**DESIGN AND CONSTRUCTION GROUP
THE GOVERNOR NELSON A. ROCKEFELLER
EMPIRE STATE PLAZA
ALBANY, NY 12242**

ADDENDUM NO. 1 TO PROJECT NO. 45545

**CONSTRUCTION WORK
RELOCATE STATE POLICE EXHIBIT
NEW YORK STATE FAIRGROUNDS
581 STATE FAIR BOULEVARD
SYRACUSE, NY 13209**

February 16, 2017

DRAWING NUMBER: A-103

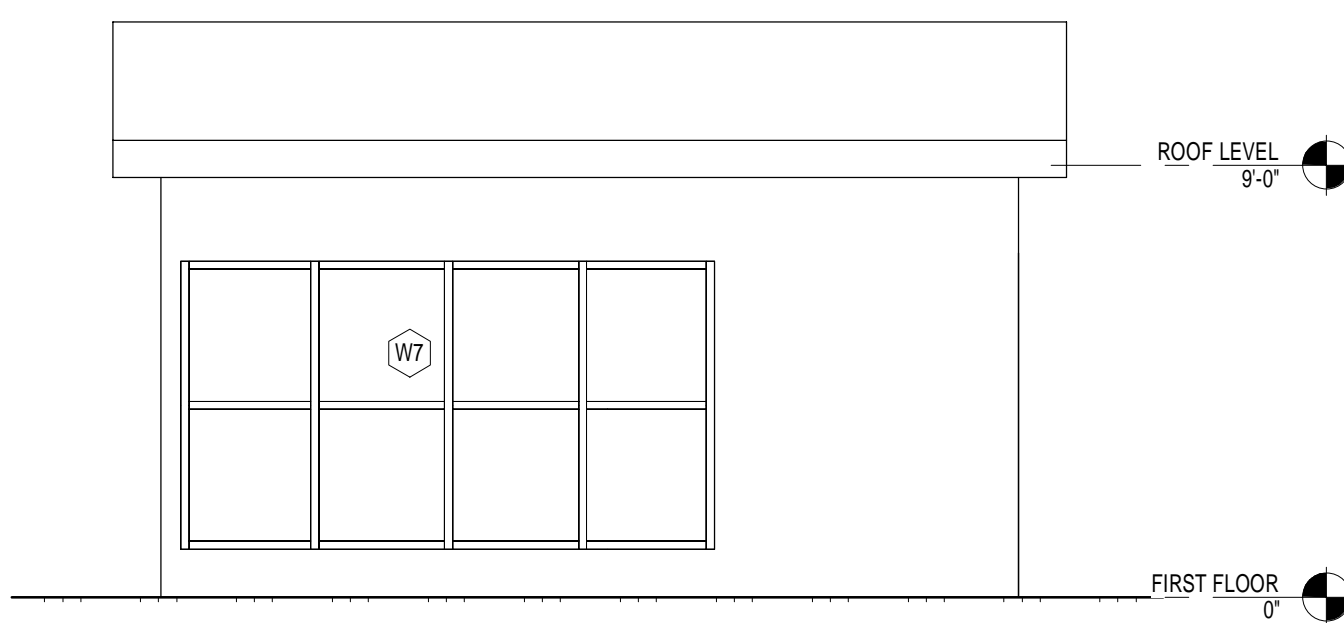
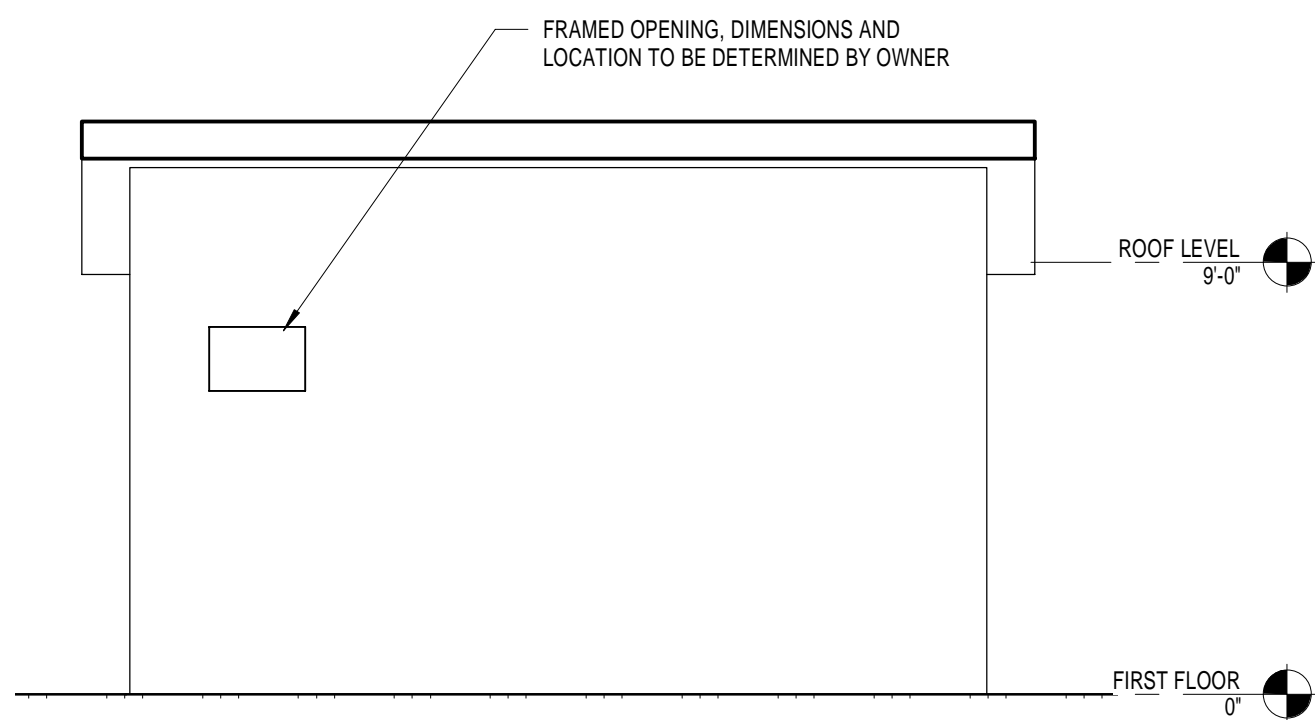
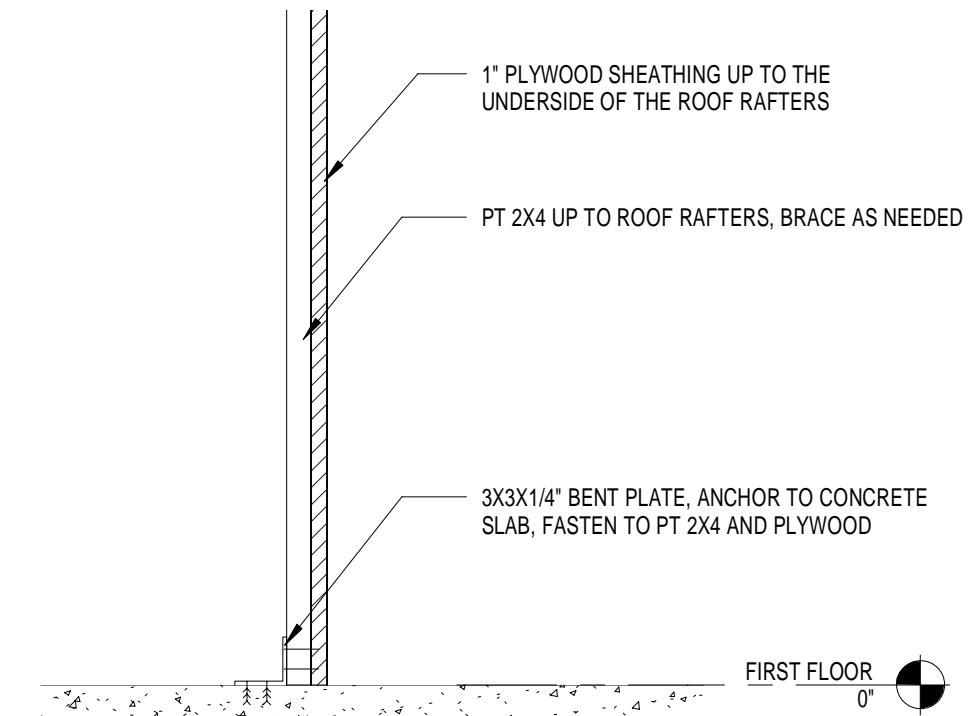
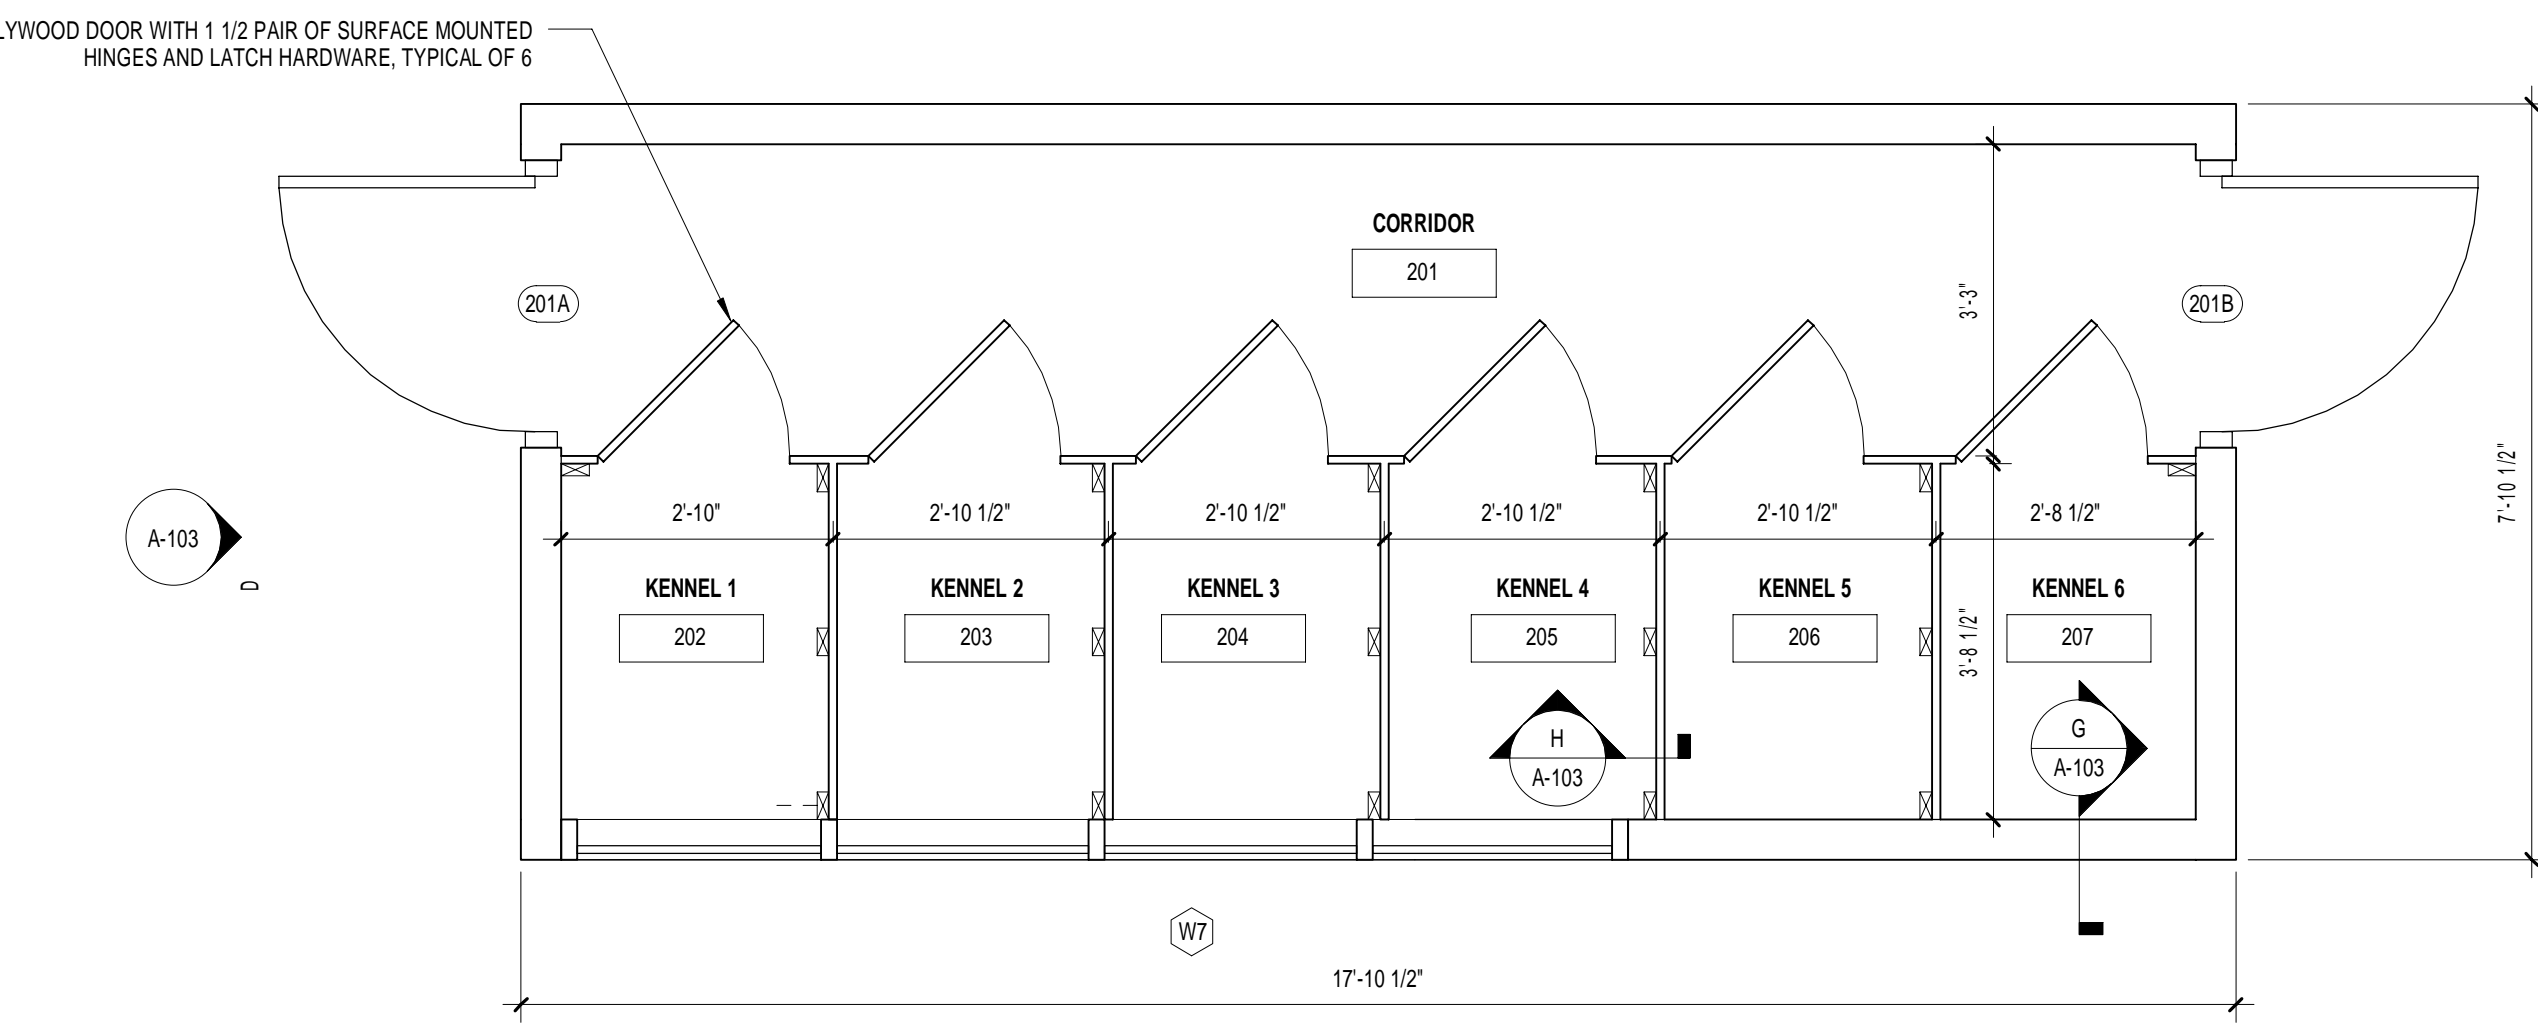
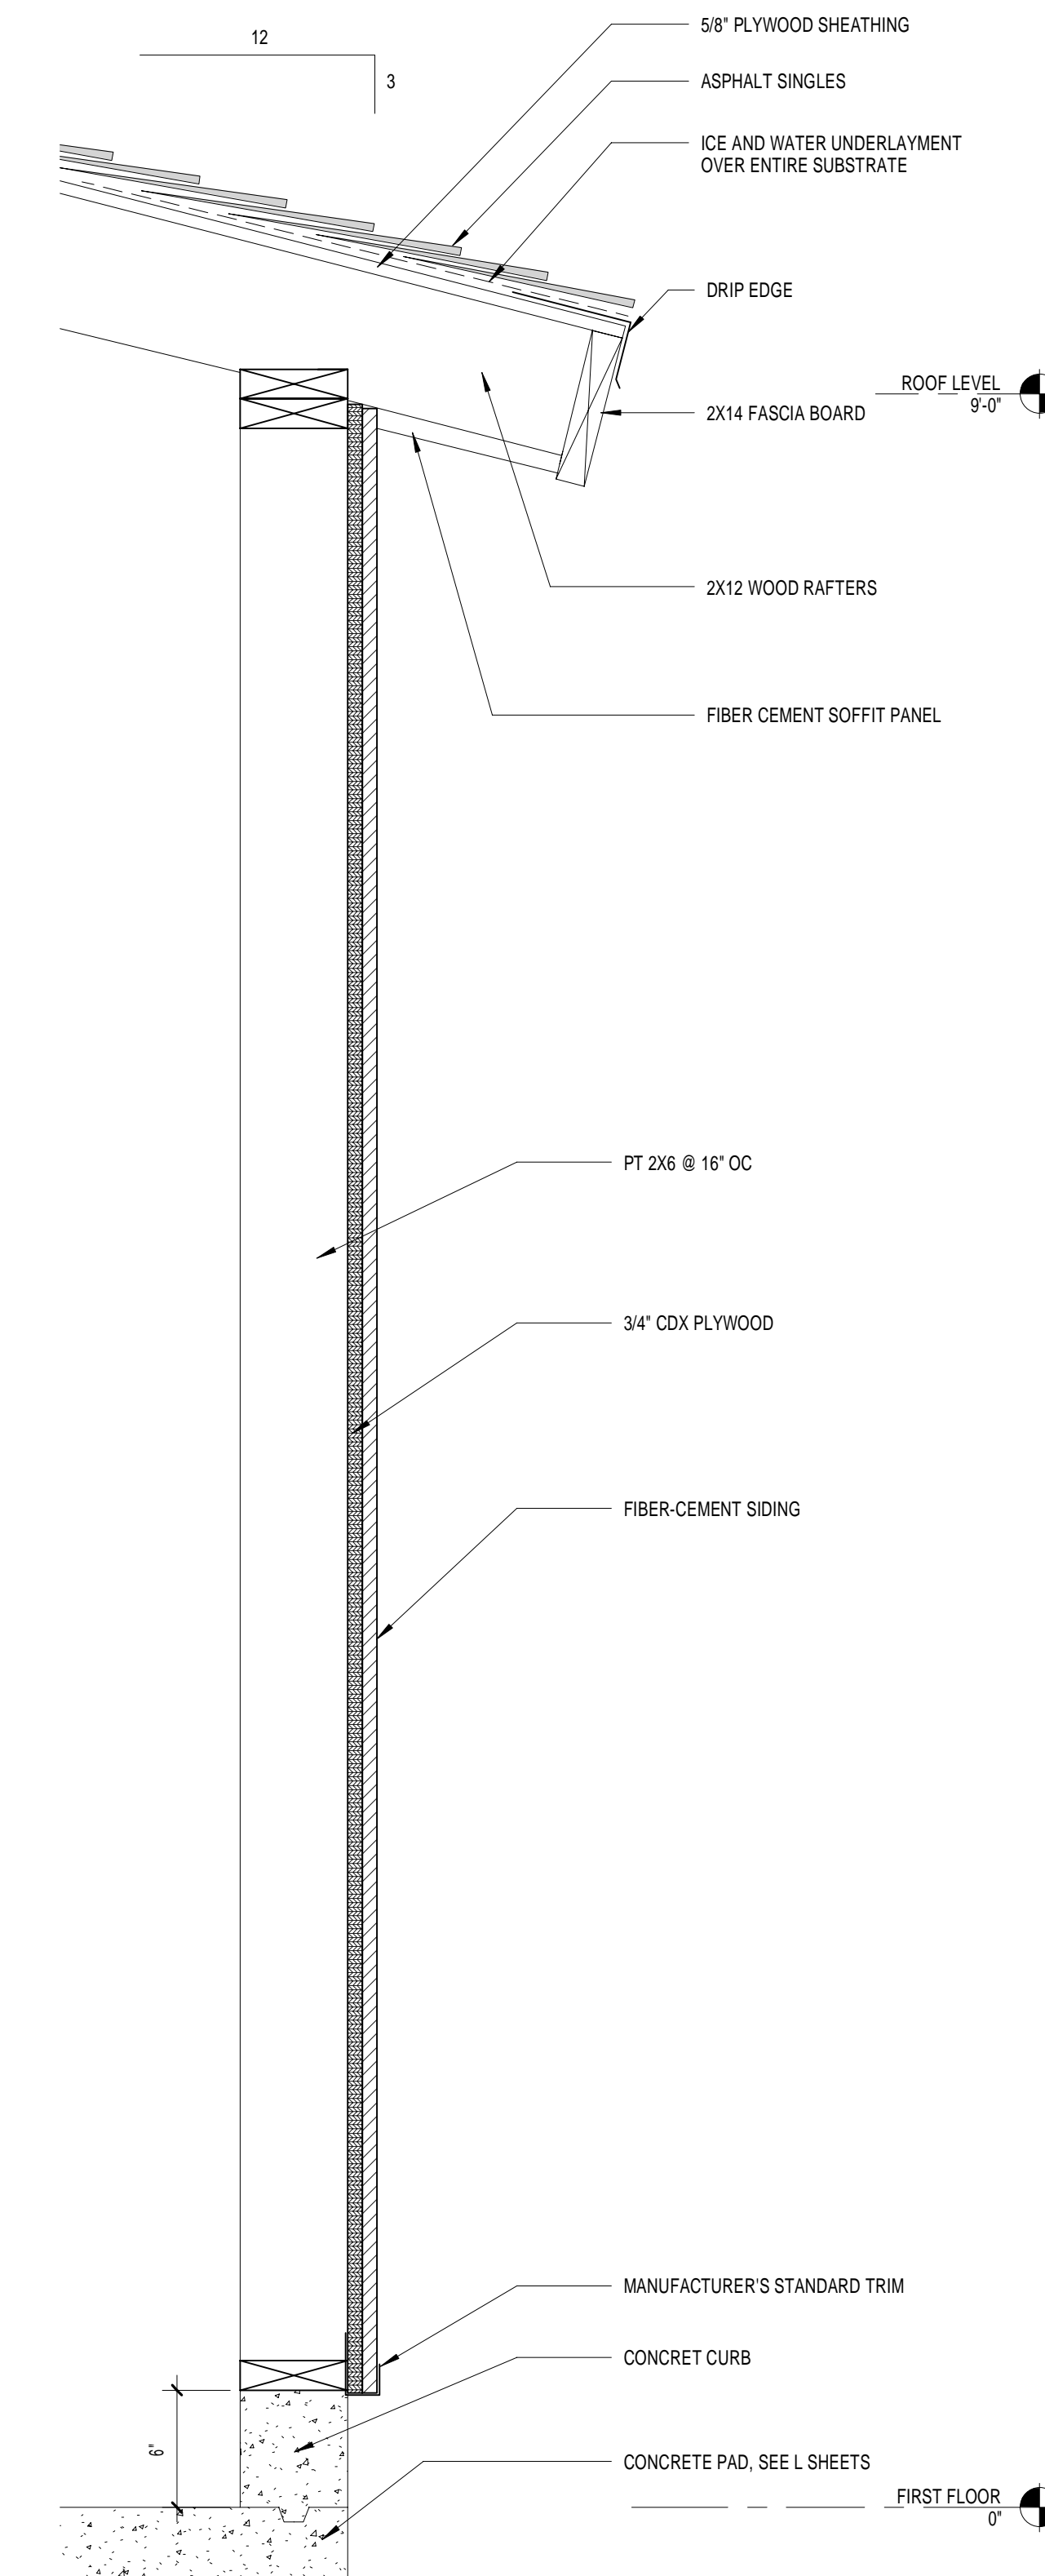
3. DRAWING A-103, KENNEL PLAN, EXTERIOR ELEVATIONS, AND DETAILS: Add to the Construction Drawings the drawing noted “2/16/17 Addendum #1” that accompanies this Addendum and modify the Cover Sheet accordingly.
